2006 IBC Structural/Seismic Design Manual, Volume 1

Errata Changes to First Printing. This errata supersedes all previous errata.

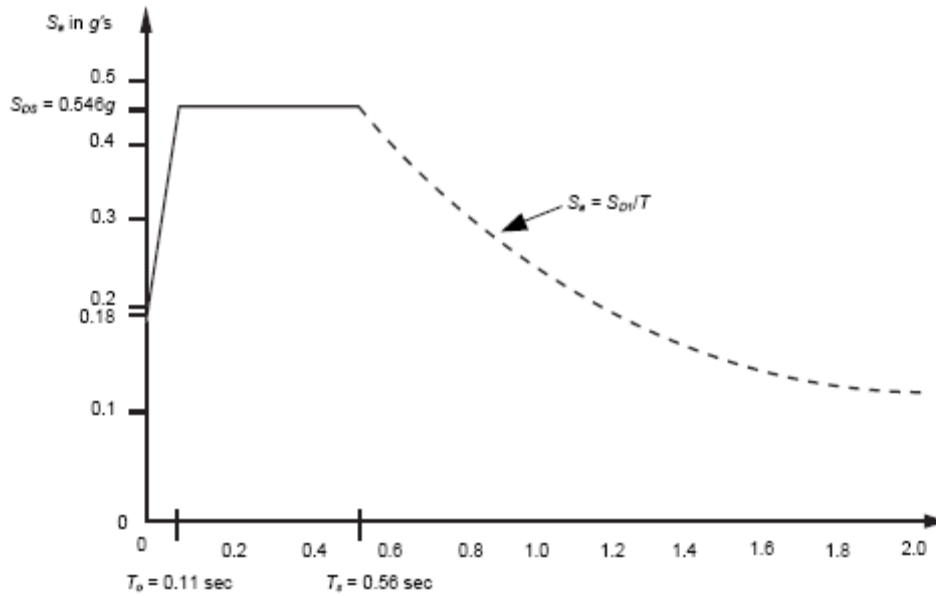
Page 38 Number 4 Equation 11.4-6 should read:

$$S_a = (S_{D1}) / T \quad (\text{Eq 11.4-6})$$

Where: $T_o = 0.20 (S_{D1} / S_{DS})$
 $= 0.2 (0.305 / 0.546)$
 $= 0.11 \text{ sec}$

$$T_s = S_{D1} / S_{DS}$$
$$= 0.305 / 0.546$$
$$= 0.56 \text{ sec}$$

Figure 15-2

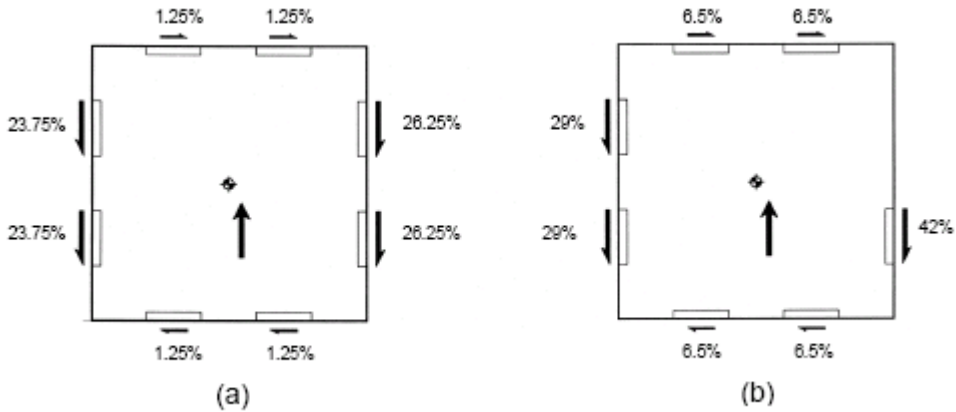
Page 72, top of page Figure 15-2 should read:

Figure 15-3

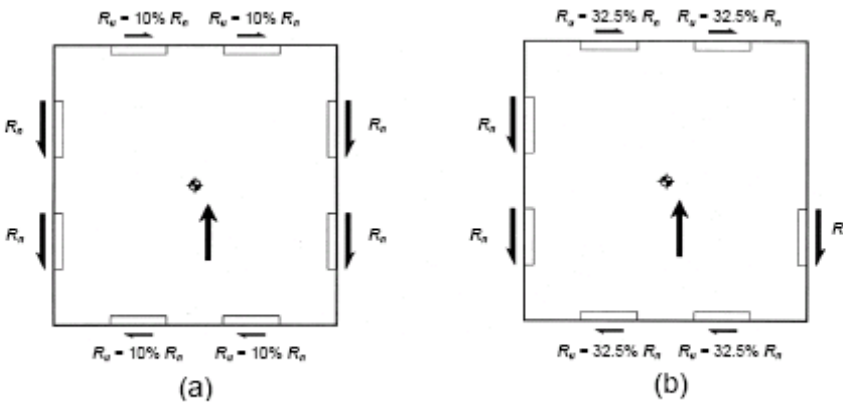
Page 72, bottom of page Figure 15-3 should read:

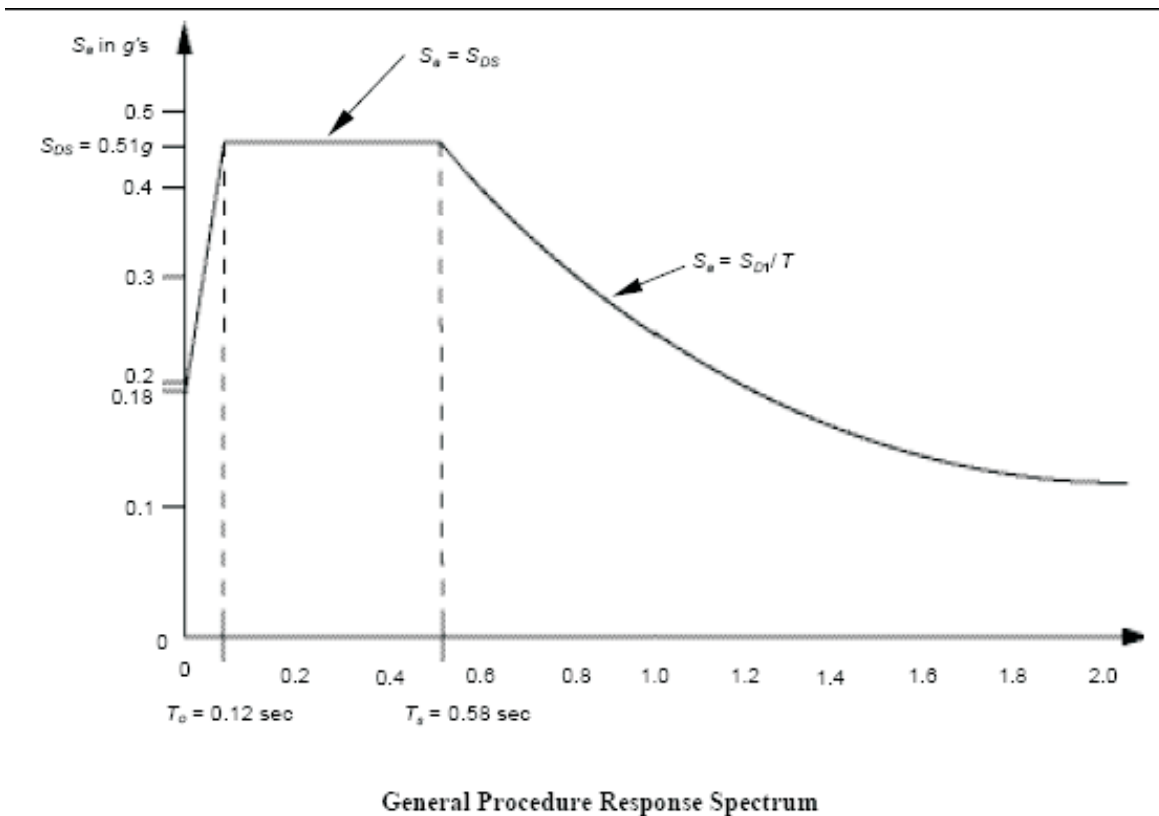
Figure on page now reads . . .
